REVIEW COMMENTS

FILE #MS-96-155

TITLE HEADING: Daughter's Cove Minor Subdivision

LOCATION: 2709 B 3/4 Road

DAUGHTERS COVE MINOR SUBDIVISION

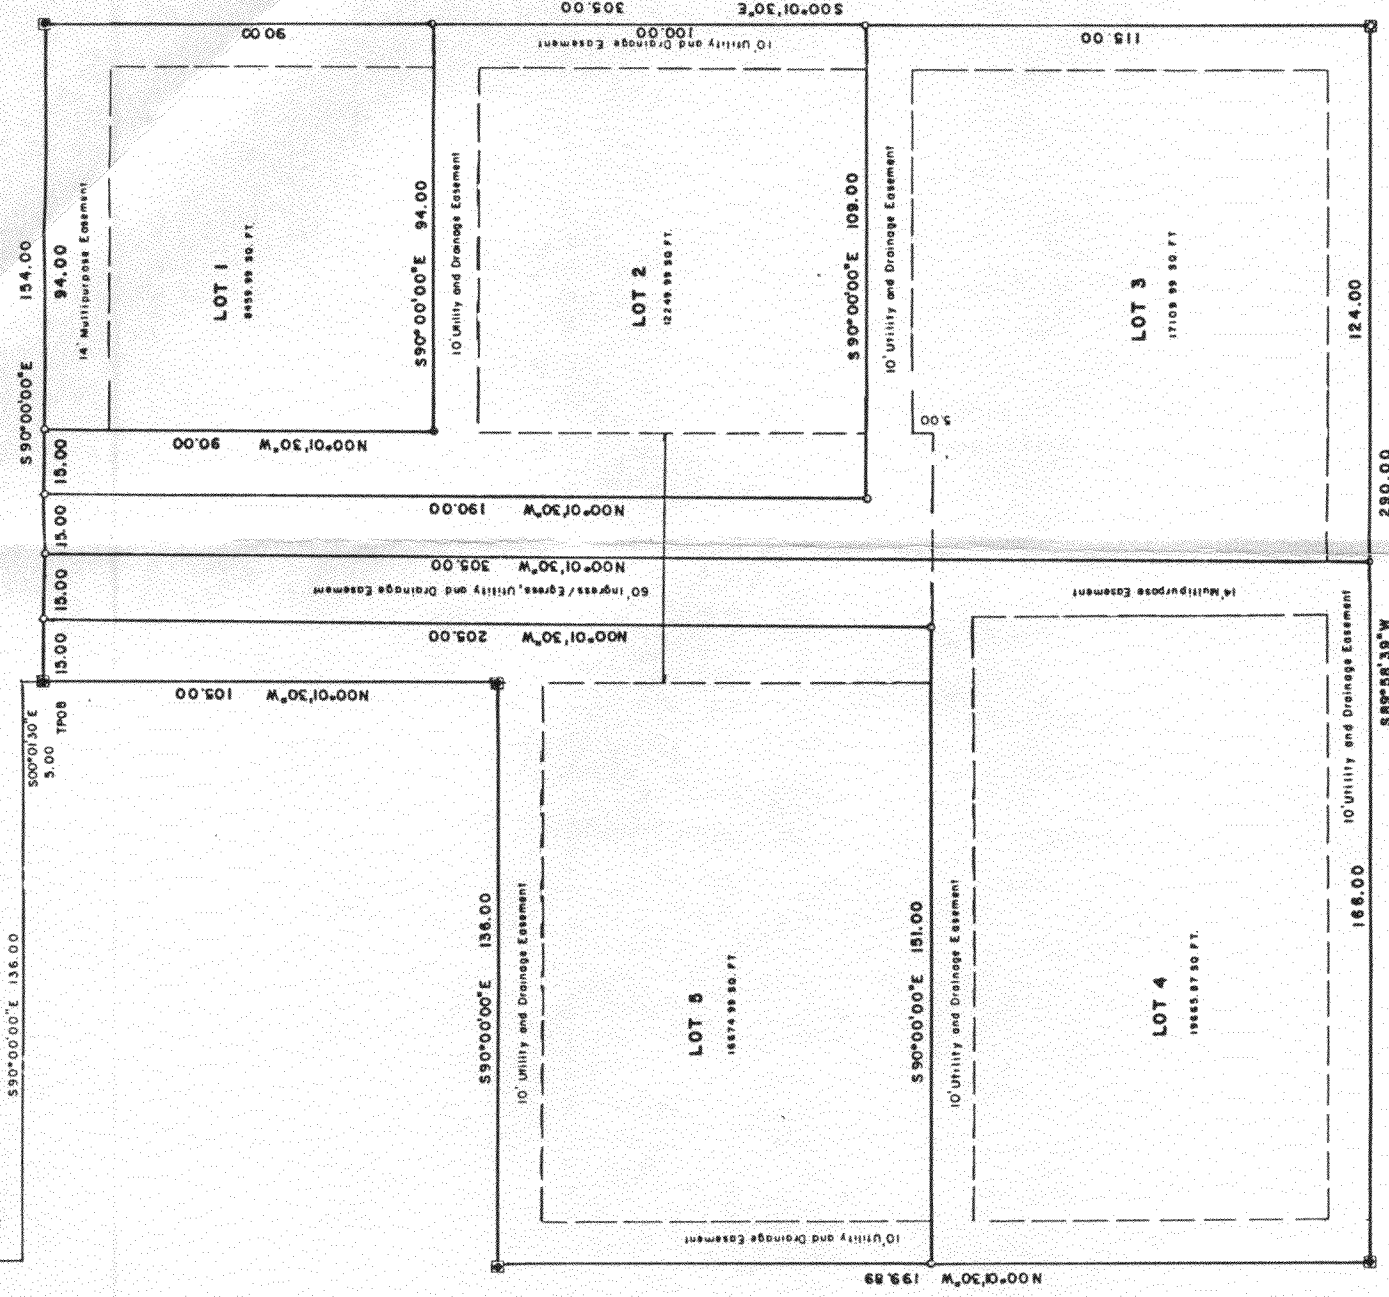
1. Plat should clearly show beginning and end of each easement.
2. What type (size, design and location) of turnaround is proposed?
3. Is a homeowner's association proposed to maintain the private accessway?
4. If there aren't any streets or roads being dedicated to the public remove this statement from the dedication portion of the plat.
5. Include a dedication statement for multi-purpose and drainage easements. Use standard city plat dedication language.
6. Provide acreages of all individual lots and also total acreage to 0.01 acres.
7. The final drainage report proposes on-site retention; the grading & drainage master plan proposes on-site detention. Which is proposed?
8. Please submit a 11" X 17" copy of the Composite Map for the Planning Commission hearing.
9. Please call Bill Nebeker at 244-1447 when you receive these comments.

- 1. The Basis of Bearings need 2 monuments to be adequate.
- 2. The surveyor's certificate should also state that this plat conforms to City of Grand Junction Development Code.
- 3. Need an area summary. Also state the acreage for each lot.
- 4. There are missing distances on the west lines of Lots 4 & 5.
- 5. Need to also address drainage and multi-purpose easements in the dedication.
- 6. Extend the 14' multi-purpose easement across the north end of Lots 2, 3, 4 & 5.
- 7. See attached map for additional comments.

STREET & STORM DRAINAGE PLAN & PROFILE WITH DETAILS
UTILITY COMPOSITE

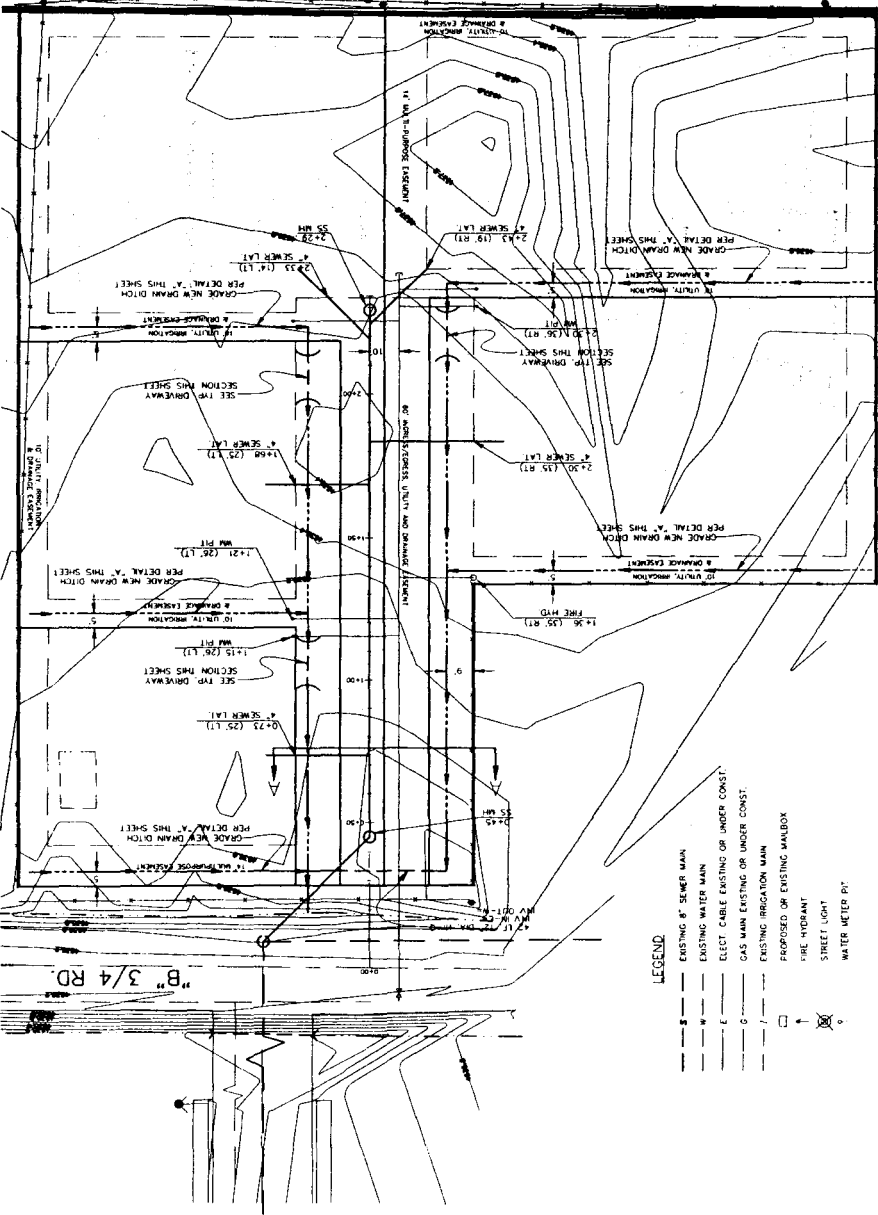
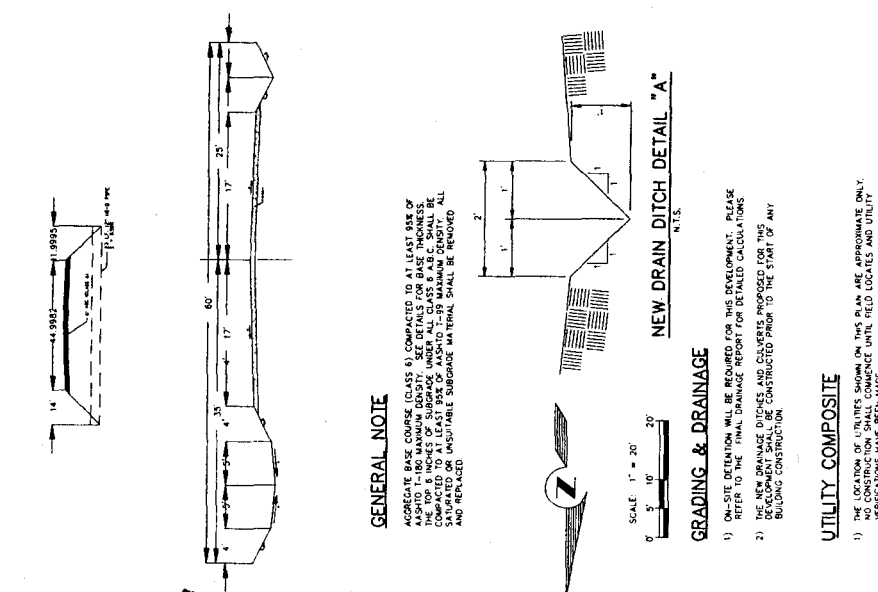
2. A separate water and sewer plan, signed and stamped by a professional engineer and approved by the Utility Engineer, will be required prior to construction of any lines to be turned over to the public. The submitted Utility Composite is inadequate for these purposes.

3. What size of water line is proposed?
 4. Coordinates or bearings/offsets are needed for manhole locations.
 5. Please ensure the final plans have the following water notes:
